TECHNICAL MEMORANDUM

To: Jim Wheeler, Development Planning Manager, City of Gresham, Oregon

Subject: Veranda Master Plan and Subdivision – Wetland 1 and Local Significance of Wetlands

SITE SOIL SECTION

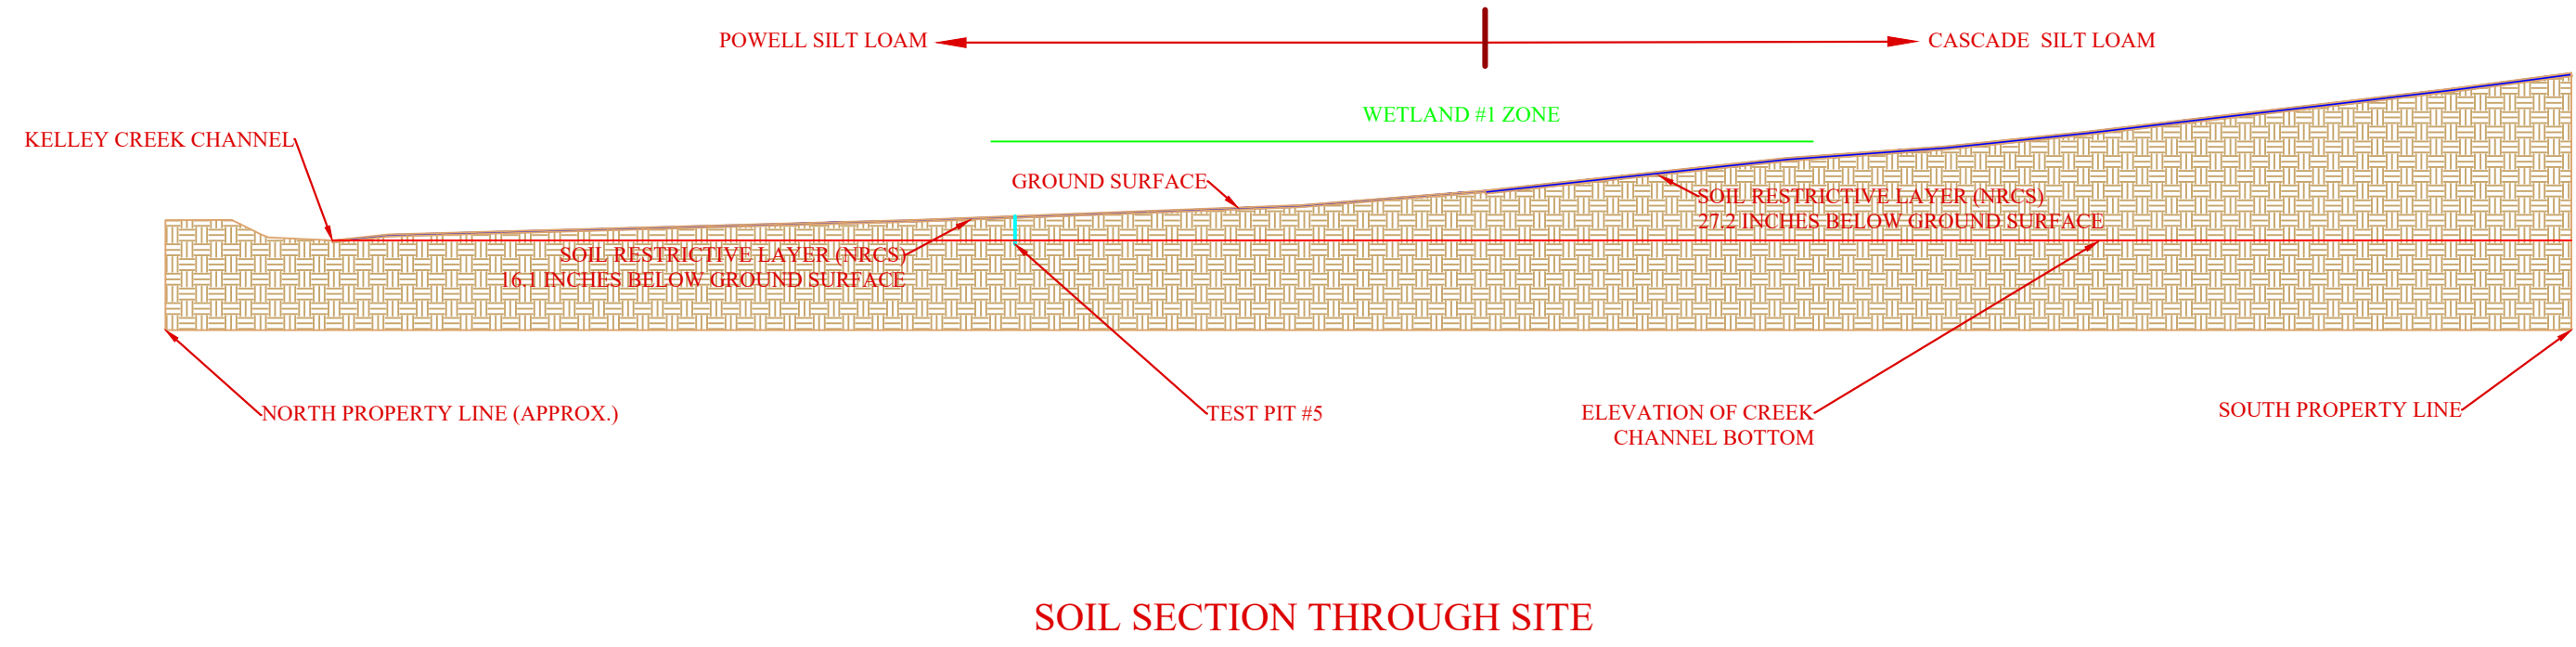
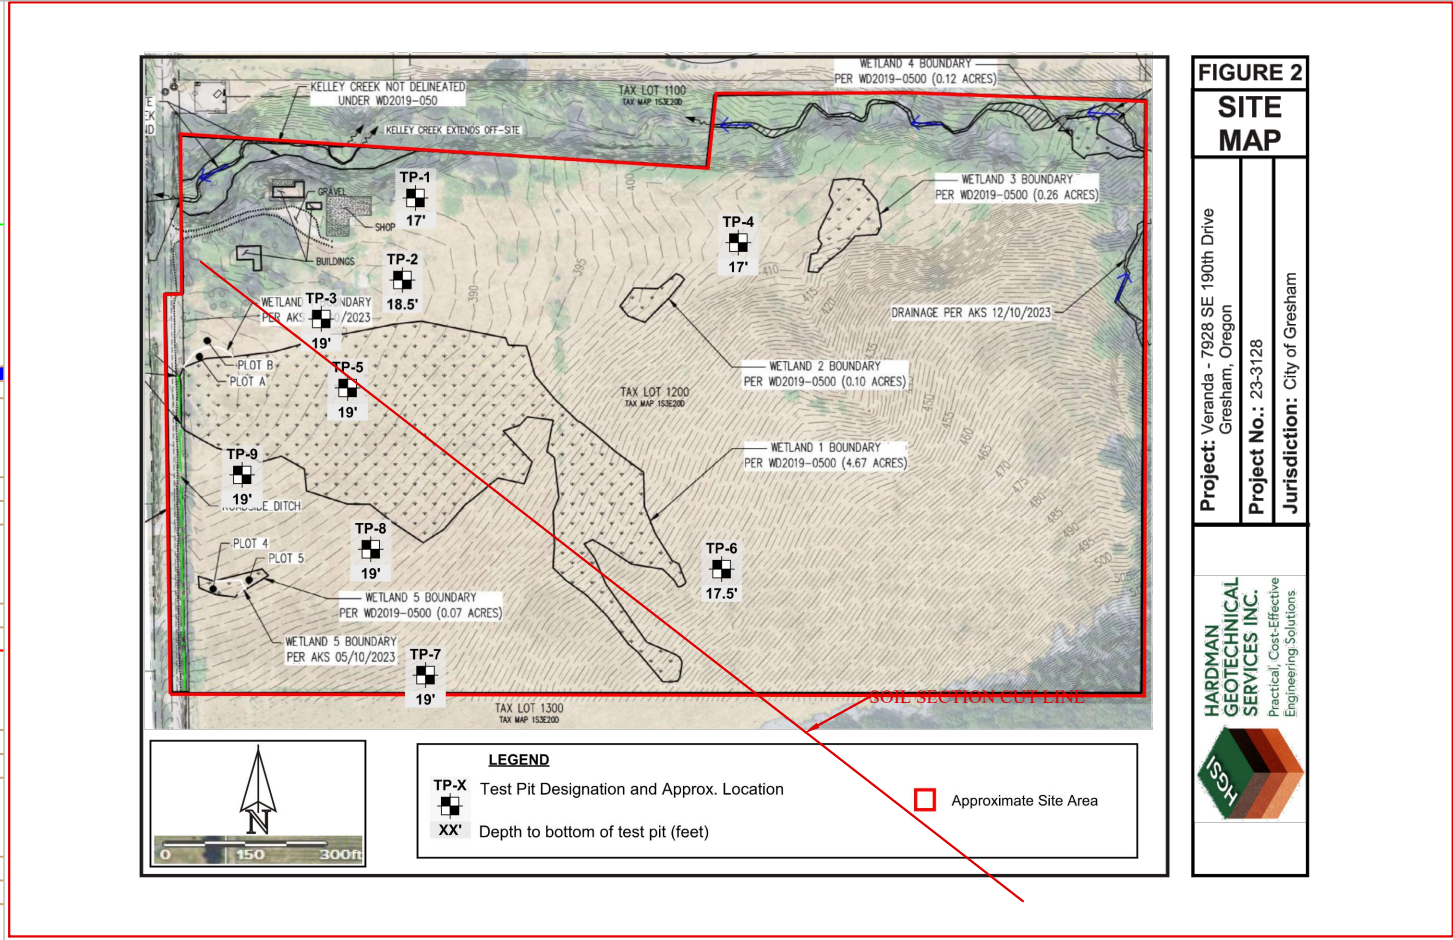
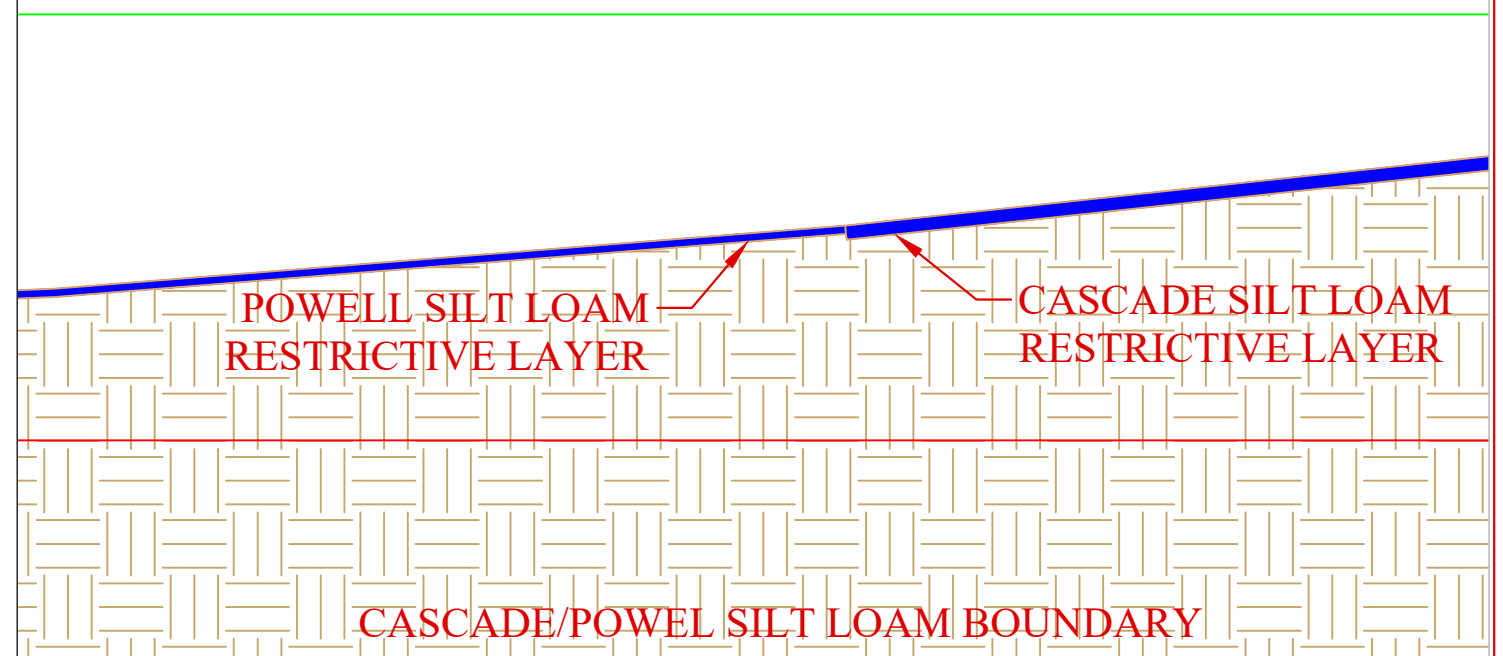
A cross section and profile through the Veranda site is provided as Attachment A. The section was cut from the north property line through Wetland 1 and to Kelley Creek. It is drawn to scale to show the physical relationships between the slopes, soils, wetland, and Kelley Creek. There is no vertical

or horizontal scale exaggeration. Site soils on top of the restrictive layer show up as a very thin band relative to the subsoils below it.

The hydrology of Wetland 1 on the Veranda site is driven by a combination of direct rainfall, surface water runoff from up slope, and shallow groundwater that is seasonally perched on the restrictive layer. The restrictive layer is a significant barrier to the flow of water downward into the subsoil and essentially isolates Wetland 1 from the underlying soil and groundwater. When sufficient rainfall and surface water runoff come into contact with Wetland 1 soils during the wetter months it will saturate the soils to some depth below the ground surface and above the restrictive layer. This is corroborated by the Schott & Associates Wetland Delineation in its description of Wetland 1 where it is stated “It is assumed the wetland is sustained by precipitation, seasonal high groundwater, and possibly hill slope seeps in the upper portion.

Depth to Any Soil Restrictive Layer—Multnomah County Area, Oregon
(Veranda - 7928 SE 190th Dr., Gresham, OR)

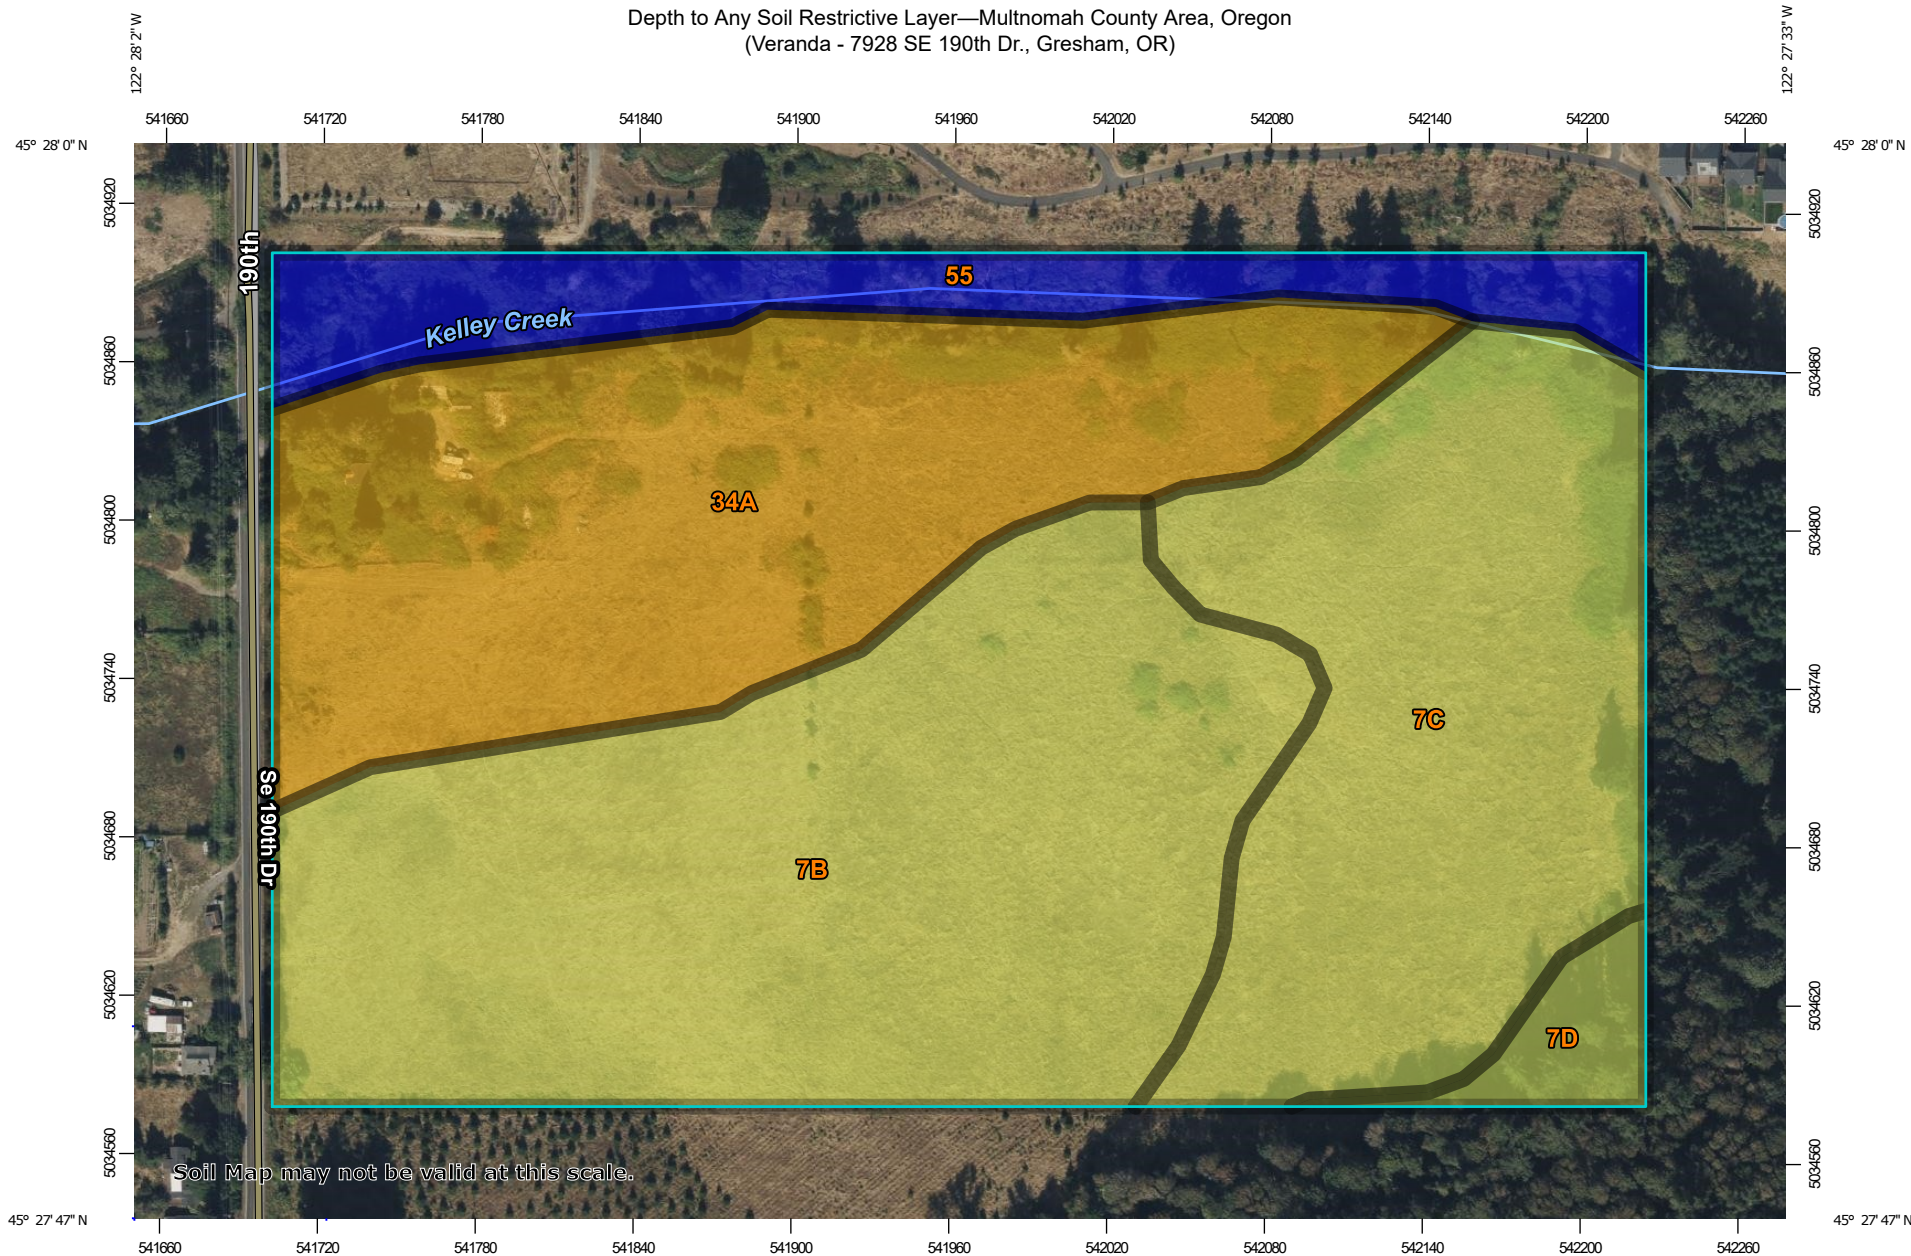
Both Cascade Silt Loam and Powell Silt Loam contain an NRCS identified “restrictive layer”, defined as “... a nearly continuous layer that has one or more physical, chemical, or thermal properties that significantly impede the movement of water and air through the soil or that restrict roots or otherwise provide an unfavorable root environment.” The NRCS has documented and reported the depth from the surface to the shallow most restrictive layer for each soil type. The shallow most restrictive layer tends to be the controlling layer. Cascade Silt Loam has a restrictive layer 69 centimeters (27 inches) below the ground surface. Powell Silt Loam, which is down slope from the Cascade Silt Loam on the site, has a restrictive layer 41 centimeters (16 inches) below the ground surface. These soils formed under similar conditions, have a similar restrictive layer, and have a similar hydrologic response as the 72 acre wetland restoration site soils I have been working with for 17 years and have monitored with shallow groundwater piezometers (wells) that recorded water level data on a daily basis.

5. The GSI Technical Memorandum dated October 31, 2023 claims that “Cool water that has infiltrated to the groundwater table and flows to Kelley Creek helps to cool stream temperatures.” This assertion is very general in nature and neglects to consider the site specific relationship between Wetland 1 and the groundwater table. Wetland 1 is perched on a restrictive layer that is only about 16 inches below the ground surface. The restrictive
